HYNET CARBON DIOXIDE TRANSPORTATION AND STORAGE PROJECT - OFFSHORE

**RESPONSE TO REQUEST FOR FURTHER INFORMATION –
REGULATION 14(1) THE MARINE WORKS (ENVIRONMENTAL IMPACT
ASSESSMENT) REGULATIONS 2007 (AS AMENDED)**

Technical Note: Physical Processes

WAE02282
25 July 2024

Figure 1-1: Indicative Offshore Power Cable alignment (red line) through West Hoyle Spit as presented in ES

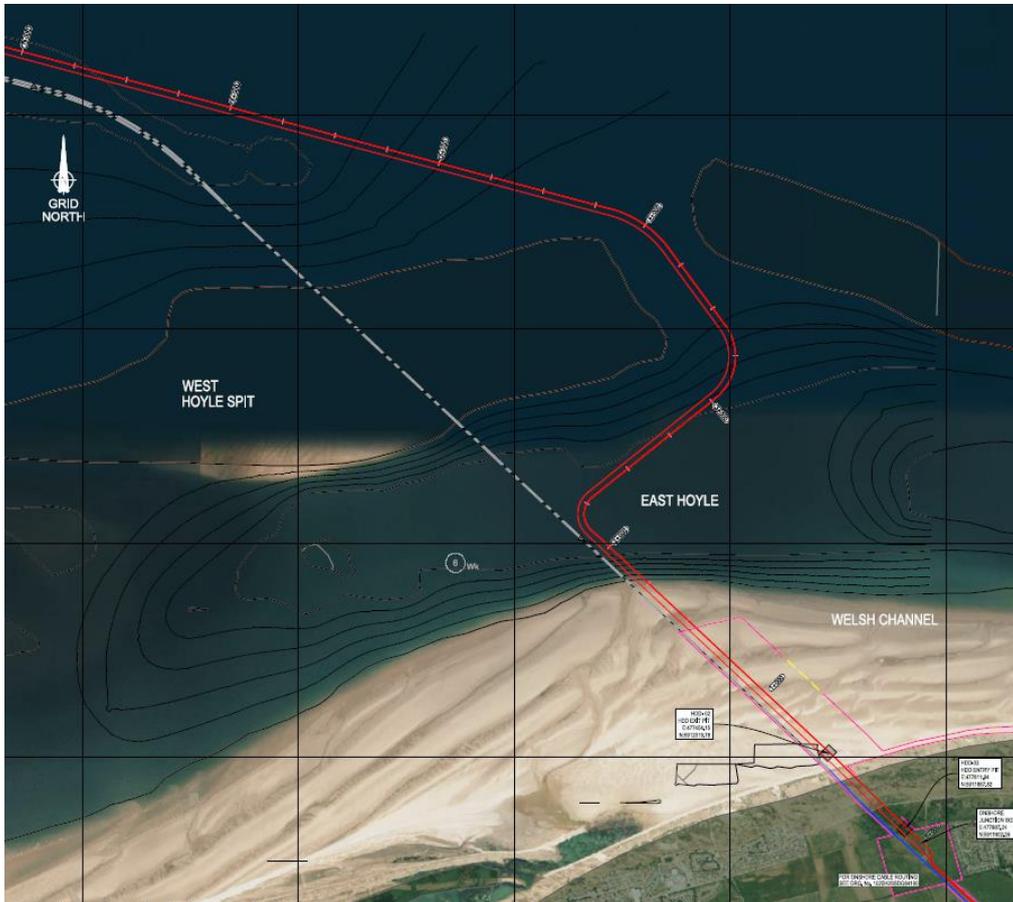
NRW	<p>The ES indicates the removal of West Hoyle bank could have significant implications to coastal flood risk and nearshore sediment transport pathways, therefore, an assessment of recoverability in terms of form and function of the sandbank from sand wave clearance (147,000m³ over two weeks) is required. NRW (A)</p>	<p>Errata</p> <p>There has been an inconsistency in the naming of the West Hoyle Spit within the ES. There are references to "West Hoyle Bank", which the Applicant appreciates is a different coastal feature located close to Hilbre Island on the east side of the Dee Estuary. This is an editorial error, and all references in the ES to "West Hoyle Bank"</p>

NRW	<p>The potential cumulative impacts of drilling and sand wave clearance within Awel y Môr array area and the activities of the proposed works are assessed. NRW (A) seek clarification whether the value of 50mg/l represents the worst-case scenario, we advise a value representative of a spring flood tide is used to assess the worst-case scenario.</p> <p>An assessment of the maximum SSC values in the area of overlap between the Port of Mostyn Energy Park and the development has been provided (up to 100 mg/l for both plumes combined). However, no assessment has been provided of the combined value of sedimentation due to the proposed works and the Port of Mostyn Energy Park. We advise this value should be provided in order to support the assessment conclusion that the effect will be negligible.</p>	<p>Further information is presented in Section 1.5.</p>
NRW	<p>NRW (A) agree with the conclusion that whilst not a designated feature, West Hoyle Bank influences the wave energy approaching the coastline and</p>	<p>Errata There has been an inconsistency in the naming of the West Hoyle Spit within the ES. There are references to "West Hoyle Bank", which the</p>

It should be noted that the project description (see Offshore ES Chapter 3) outlined two potential cable routes between the Point of Ayr and the New Douglas platform. The “worst case scenario” followed in parallel alignment with the existing natural gas pipeline crossing West Hoyle Spit whilst the “preferred option” runs to the east and does not cross West Hoyle Spit. Through the assessment of alternatives process which forms an integral part of any EIA, and ongoing discussions with cable installation contractors, the preferred option has been identified for cable installation and the West Hoyle Spit will remain undisturbed. The cable route will pass

through the natural channel sited to the east of the Spit, as illustrated in Figure 1-1, which shows the alignment presented in the ES. Therefore the future baseline scenario and post construction scenarios in terms of physical processes are indistinguishable in this respect. Further refinement of the preferred route alignment has recently been carried out, as shown in Figure 1-2, which has eliminated the right angled bends along the first 3.25 km of the cable route from the HDD exit pit at the MHS mark on Talacre Beach and around West Hoyle Spit.

Figure 1-3: Other Projects, Plans and Activities Screened into the Cumulative Effects Assessment

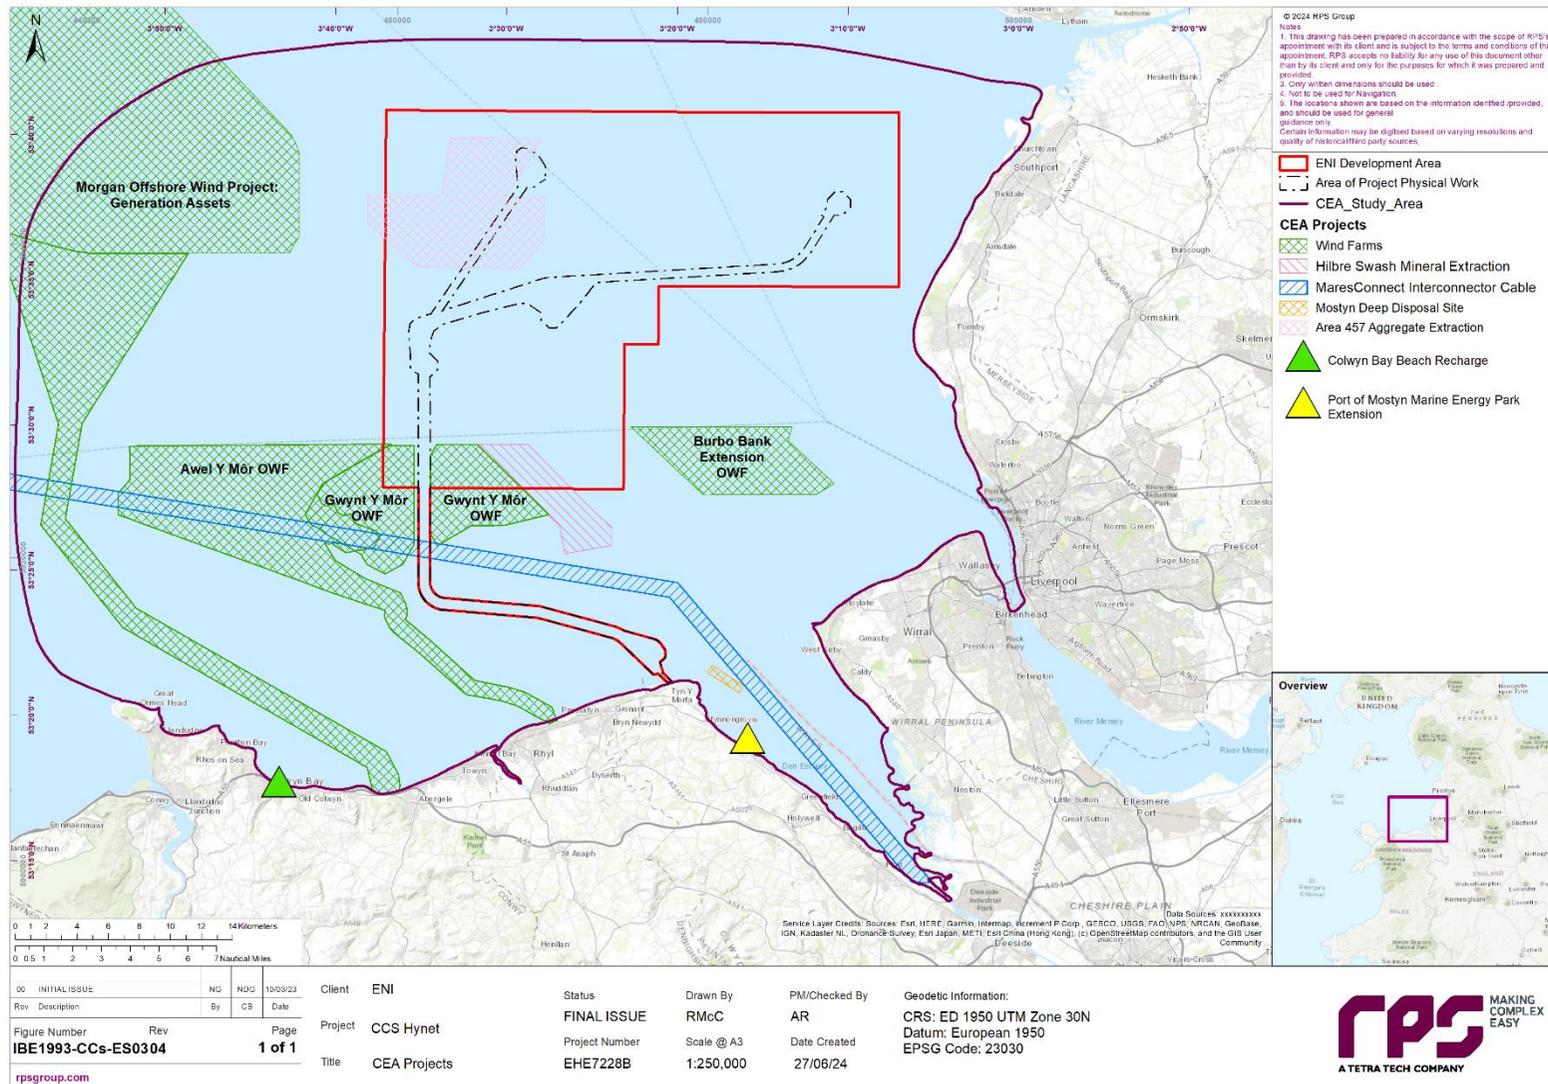
<p>Natural England</p>	<p>We note that the following projects have not been included in the list of other projects, plans and activities considered within the CEA:</p> <ul style="list-style-type: none"> • Area 457 aggregate extraction renewal licence (EIA/2023/00003). • Mersey Tidal Power Project (due to submit EIA scoping report in Q3 2024). 	<p>Further information is presented in Section 1.5.</p>
<p>NRW</p>	<p>NRW (A) seek clarification on the correct amount of subsea power cable to be installed. We are concerned the worst-case scenario might not have been assessed in the ES. We also seek clarification on what dimensions were used for the numerical modelling undertaken in Volume 3, Appendix H, Physical Processes Technical Report.</p>	<p>The Applicant would like to reassure NRW that there are no inconsistencies in the reported lengths of cables.</p> <p>Chapter 3 describes that there are five proposed electrical cables in total:</p> <ol style="list-style-type: none"> 1. From Point of Ayr to Douglas, there are the 2 x cables in parallel from PoA to Douglas OP each of which is 33,990m in length. That makes 67.98km (67,980m). <i>(We acknowledge that this has on occasion been rounded to 70km).</i> 2. From Douglas OP to Hamilton North satellite platform, 32.34km. 3. From Douglas OP to Hamilton Main satellite platforms, 14.89km. 4. From Douglas OP to each of the satellite platforms, 32.34km, 14.89km, and 10.87km respectively. <p>This equals a total linear distance for all five cables of 126.04km, as also stated in ES Chapter 7.</p>

In terms of additional projects the Mostyn Energy Park Extension (MEPE) was included in the physical processes CEA with the ES Chapter 6: Physical Processes. This project was added to the assessment as an outcome of the NRW Fitness Check. The Mersey Barrage is a Tier 3 project for which there is little detail at this point, as the project is yet to submit scoping or make an application. From what is known of the project, the construction phase will not overlap with that of the Proposed Development. The potential impacts on physical processes for the Proposed Development have been determined to be SSC, water quality, and seabed morphology whilst the principal impact of the barrage is likely to be changes to tidal flows. Whilst the operational phase would ultimately overlap, the Proposed Development would not alter tidal flows as, apart from cable protection at cable crossings, the new infrastructure is below bed levels and the remainder of the infrastructure is pre-existing, having been in place for the past 30 years. Further updates to the physical processes CEA are provided in the following section. This includes the Area 457 aggregate extraction renewal licence, illustrated in Figure 1-3, which has moved forward since the Offshore ES document was prepared.

Westminster Gravels will be renewing their aggregate extraction licence in Area 457 in Liverpool Bay. This area is shown relative to the Area of Project Physical Work in Figure 1-3. The Environmental Statement [for the licence renewal](#) is planned for submission in 2024. [The Area 457 aggregate extraction is currently operational with the current licence being granted in 2012 for extraction until 2025. Elevated SSC due to current activities would therefore form part of the existing background environment. By the nature of this project, increases in SSC are intermittent and the timing of specific aggregate extraction activities would determine and as such this is a Tier 3 project. This is because there is no current information regarding the timing of any proposed activity, and](#) whether dredging activity would coincide with the construction phase of the Proposed Development. The Area 457 spans the Douglas to Hamilton North cable therefore cumulative impacts are likely if the aggregate site is active when the northern section of the Douglas to Hamilton North cable is being installed. Although, due to the east to west orientation of tidal flow, activities in other areas are unlikely to cause cumulative impacts. The maximum SSC beyond the immediate vicinity of the cable installation (i.e. c. 100 m) would be in the order of 100 mg/l to 300 mg/l, whilst the maximum sedimentation in these areas would be 1 mm to 3 mm. The contribution from extraction activities will depend largely on the volume and method used to remove material. Generally, during aggregate extraction, spill levels are kept to a minimum (c. 3%) to provide cost efficient extraction. Any cumulative SSC and sedimentation would not extend to any of the designated areas or relevant qualifying interests for the physical processes assessment.

Figure 1-4: Typical Schematic Layout of Concrete Mattress Protection at Cable Crossing

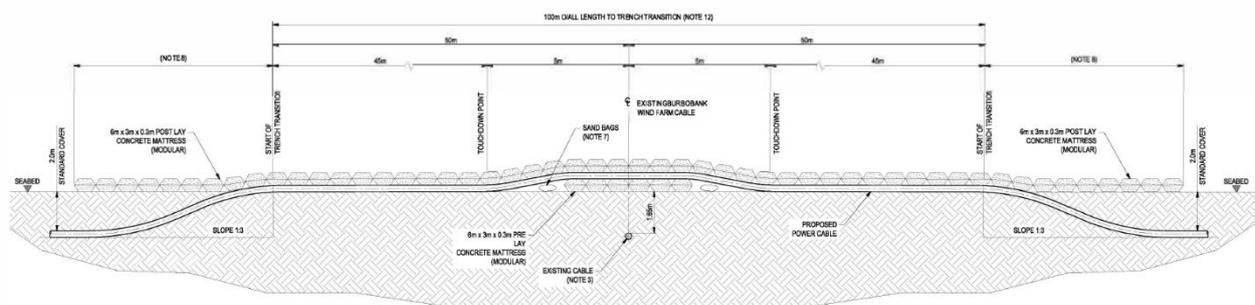
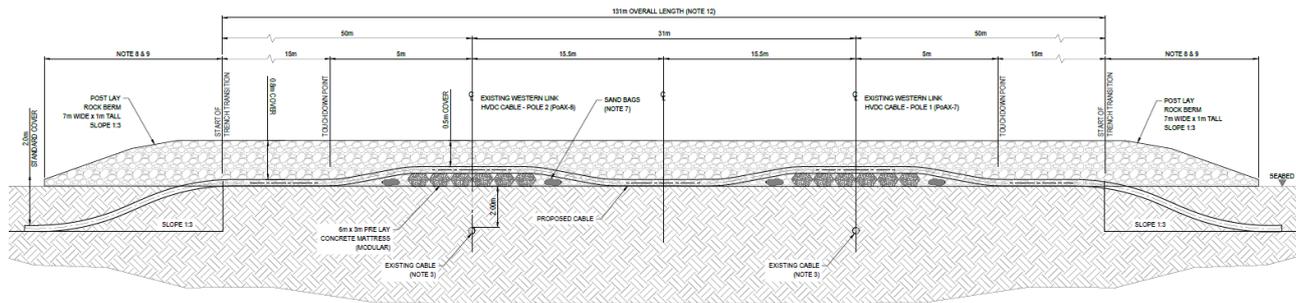
Consultee	Consultation	Where and How Addressed
NRW	<p>NRW (A) seek clarity on the commitment and ability for cable protection height to affect no greater reduction in water depth than 5% where cable crossings are required in 5.8m water depth, equating to protrusion of no more than 0.29m.</p> <p>NRW (A) seek clarification on the course of action in the event the commitment to 'no greater reduction in water depth than 5%' is not practical.</p>	<p>Further information is presented in Section 1.6: Cable crossings in shallow water.</p>
NRW	<p>The assessment of changes to SSC and sediment deposition uses average values from the modelling study. Average values of modelled SSC and sediment deposition values do not represent the worst-case scenario required to appropriately assess secondary impacts to other receptors such as Benthic, Fish and Ornithology. Maximum values of SSC and sediment deposition values are required to determine the significance of secondary impacts of elevated SSC and sediment deposition values arising from the proposed seabed preparation and cable installation works before cumulative impacts can be considered appropriately. NRW (A) advise that the assessment should clearly state how maximum values of SSC and sediment deposition vary with time and distance as a result of works included in the construction phase.</p>	<p>Further information is presented in Section 1.4.</p>

The project description (Offshore ES Chapter 3) includes details of the cable crossings in Table 3.6 which is reproduced below in Table 1-2. This table outlines all the cable crossings that are along the Point of Ayr to Douglas platform cable. The cable crossings for the inter-platform cables to the three satellite platforms are either within the 500 m clearance zone of the New Douglas platform, and/or cross Eni infrastructure. All are in water depth in excess of 25 m. Table 1-2 gives the water depths, and water depths above berm height. This shows that for crossings PoAX 1 (Burbo Bank OWF), PoAX 2 & 3 (North Hoyle OWF), and PoAX 4 & 5 (Gwynt y Môr OWF) there will be a reduction in clearance above the berm 0.8 m in height, as the water in these locations is very shallow; 5 m, 7 m, and 12 m respectively. The revised project description has determined that only one cable will now be installed, so only three export cable crossings (PoAX 1, 2, & 4) will be required within limited water depths where the restriction of 5% water depth reduction to cable protection height cannot be met throughout the tidal cycle.

In such cases the design of the cable crossing reduces the potential impacts of physical processes by the use of layered protection which gradually changes in height, as illustrated in Figure 1-4 and Figure 1-5. Each layer of the modular post lay concrete mattress is 0.3 m in height. At the approach to the crossing there will be a single layer of mattressing which then overlays the cable as it emerges from the bed and is surface laid. The cable will then be laid over a single layer of mattressing placed on the bed at the crossing point. This is then covered with either a single layer of mattressing, or rock. For crossings PoAX-1, and PoAX-2 the concrete mattress protection as shown in Figure 1-4, the distance of the touchdown points either side of the crossing is circa 5 m. Therefore the 0.8 m berm height occurs for a limited distance <10 m and for the majority of the crossing the obstruction on the bed is between 0.3 m and 0.5 m in height (i.e. a small proportion of each shallow water crossing exceeds 5% of the water depth). The rock protection for PoAX-4 shown in Figure 1-5 the 0.8 m berm height will occur over its full length of up to 200 m. Therefore, only crossings PoAX-1, PoAX-2, and PoAX-4 will be within very shallow water and will form a gradual reduction in water depth, lowering the potential impacts of physical processes.
